APPLICATION FOR UNDERGROUND STORAGE FACILITY PERMIT (A.R.S. § 45-811.01)

Application No: 71-584469-0001

SUBJECT: Modification of Superstition Mountains Community Facilities District No.1 (SMCFD) Underground Storage Facility (USF) Permit 71-584469.0000

SMCFD No. 1 Updated 2011 Recharge Facility Map Phasing Plan

UPDATED 2011 RECHARGE FACILITY MAP PHASING PLAN

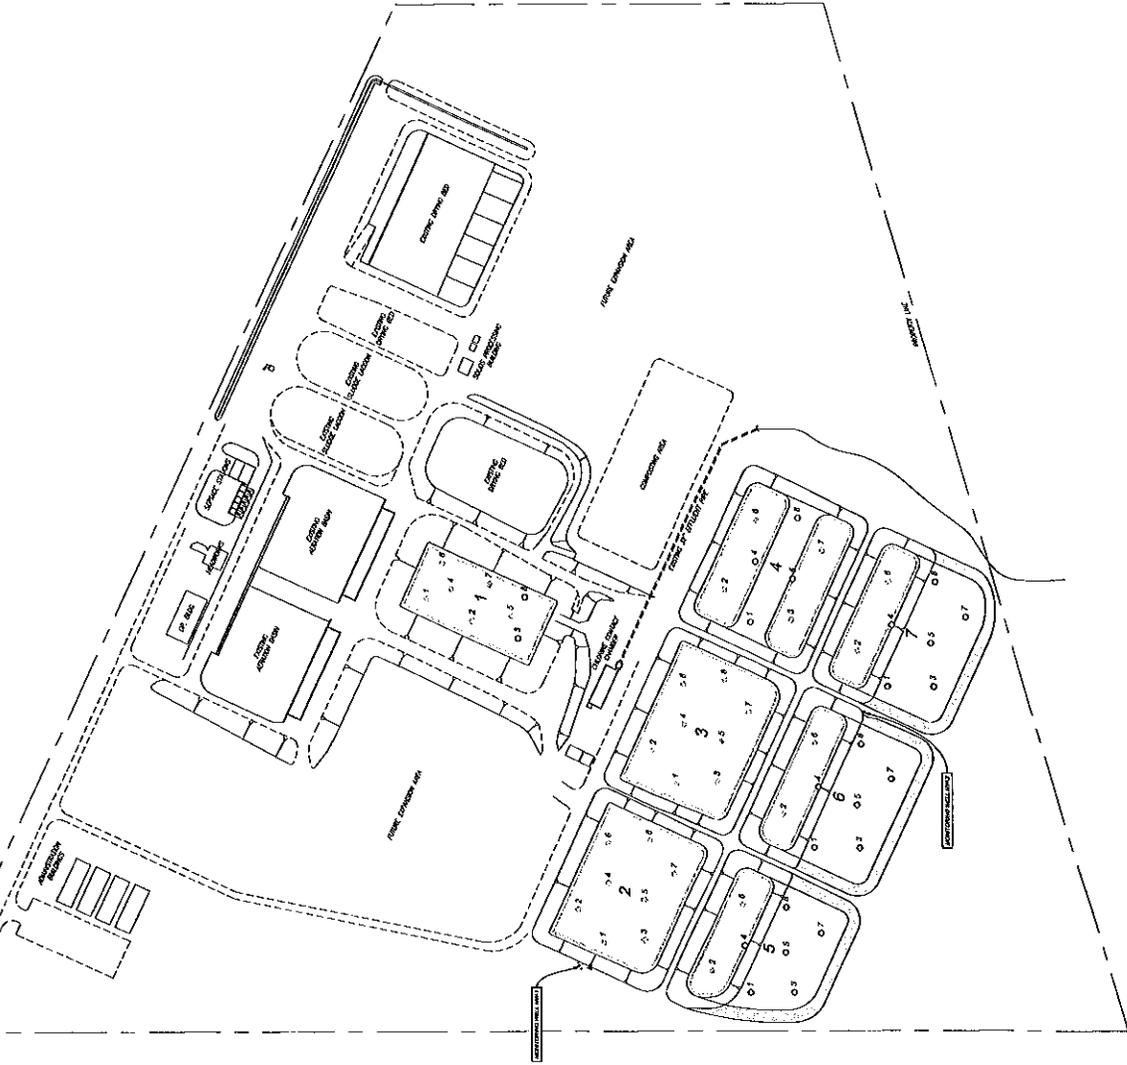
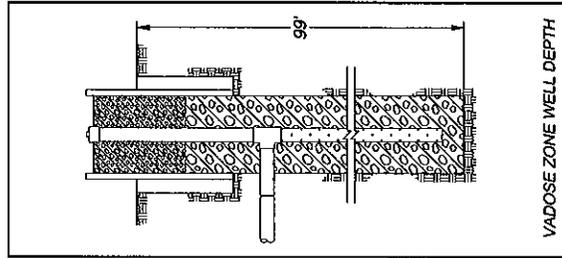
In order to achieve the desired operational efficiency of the recharge facility, additional space was necessary to accommodate an increased number of vadose zone recharge wells. In the Updated 2011 Recharge Facility Map (Attachment I), the recharge basins and vadose zone well locations, including all proposed future modifications, are clearly shown. Construction of the recharge facility has been divided into three phases. Phase I construction modifications have been completed. Phase II and Phase III construction modifications will be initiated as the need for additional vadose zone recharge wells and recharge basins become necessary to meet the maximum recharge capacity of the recharge facility of 2.1 MGD. For clarity, basin numbers referring to the existing basins use the prefix EB; basin numbers following the proposed design changes in the USF modification use the prefix RB.

The size and shape of EB-1 was not modified during Phase I. Permit modifications for Recharge Basin 1 (RB-1) will require the name change to Recharge Basin 1, and a recalculated maximum wetted area of 0.585-ac. During Phase I construction, the berm between existing basins EB-2 and EB-5 was removed to form Recharge Basin 2 (RB-2). Likewise, the berm between existing basins EB-3 and EB-6 was removed to form Recharge Basin 3 (RB-3). Permit modifications for RB-2 requires the name change to Recharge Basin 2, and a new maximum wetted area of 1.148-ac. Permit modifications for RB-3 requires the name change to Recharge Basin 3, and a new maximum wetted area of 1.187-ac. All Phase I components are currently complete.

Phase II construction will include removal of the berm between existing basins EB-4 and EB-7 to form Recharge Basin 4 (RB-4). Permit modifications for RB-4 requires the name change to Recharge Basin 4, and a new maximum wetted area not to exceed 1.226-ac. Phase II construction modifications will be initiated as the need for additional vadose zone recharge wells and recharge basins become necessary to meet the maximum recharge capacity of the recharge facility of 2.1 MGD. This may occur as early as calendar year 2012.

Phase III construction involves expansion of existing basins EB-8, EB-9, and EB-10 to form Recharge Basins 5 (RB-5), 6 (RB-6), and 7 (RB-7), respectively. Permit modifications for RB-5, RB-6, and RB-7 require the name changes to Recharge Basin 5, Recharge Basin 6, and Recharge Basin 7, and a new maximum wetted area of approximately 1.5 acres for each basin. Phase III

As described above, the primary method of recharge for the updated recharge facility is now accomplished through direct injection of effluent to vadose zone recharge wells. This change requires the addition of up to thirty-six (36) vadose zone recharge wells to the existing permit. The Updated 2011 Recharge Facility Map (Attachment I) shows the location and phases of existing and proposed vadose zone recharge wells and includes a total of eight (8) wells in each of the seven (7) recharge basins.

Phase I construction modifications to the USF are complete. Phase I included the installation of four (4) additional vadose zone (recharge) wells in each of Recharge Basins 1, 2, and 3. Currently there are a total of six (6) wells in RB-1, and a total of eight (8) wells in RB-2 and RB-3, respectively. At the conclusion of Phase I, a total of thirty-two (32) vadose zone recharge wells have been installed at the facility (Attachment I).

Phase II construction will be initiated as the need for additional vadose zone recharge wells become necessary to meet the maximum recharge capacity of 2.1 MGD. In addition to the recharge basin modifications discussed above, Phase II is planned to include the addition of six (6) more vadose zone (recharge) wells: two (2) in RB-1, and four (4) in RB-4.. At the conclusion of Phase II, the recharge facility will have a total of thirty-eight (38) vadose zone (recharge) wells.

Phase III construction modifications will be initiated as the need for additional vadose zone recharge wells becomes necessary to meet the maximum permitted recharge capacity of 2.1 MGD. To this end, Phase III may include the addition of up to eighteen (18) more wells at the recharge facility. As part of this permit modification, an additional six (6) wells will be constructed during Phase III in RB-5, RB-6, and RB-7, respectively. At the conclusion of Phase III (build-out), each of the seven (7) recharge basins will have eight (8) wells for a total of fifty-six (56) direct injection vadose zone recharge wells at the facility.

Phases I, II, and III proposed construction modifications are shown in the Updated 2011 Recharge Facility Map (Attachment I). During Phase I, RB-1, RB-2, and RB-3 were constructed or modified with installation of four (4) vadose zone (recharge) wells in each basin, respectively. Phase I construction is complete. During Phase II, RB-4 will undergo modifications that include the removal of the interior berm and the installation of four (4) more vadose zone recharge wells. Phase II will also include the installation of two (2) more wells in RB-1. Phase II construction will commence as additional recharge capacity is necessary, and may occur as early as calendar year 2012. Proposed Phase III recharge facility components are intended as final effort to increase recharge capacity as needed to maintain the permit maximum up to 2.1 MGD. This contingency is necessary to increase the efficiency of the operation of the recharge facility with the construction of larger basins for RB-5, RB-6, and RB-7 and the installation of up to six (6) additional vadose zone recharge wells in each of these three recharge basins, respectively.
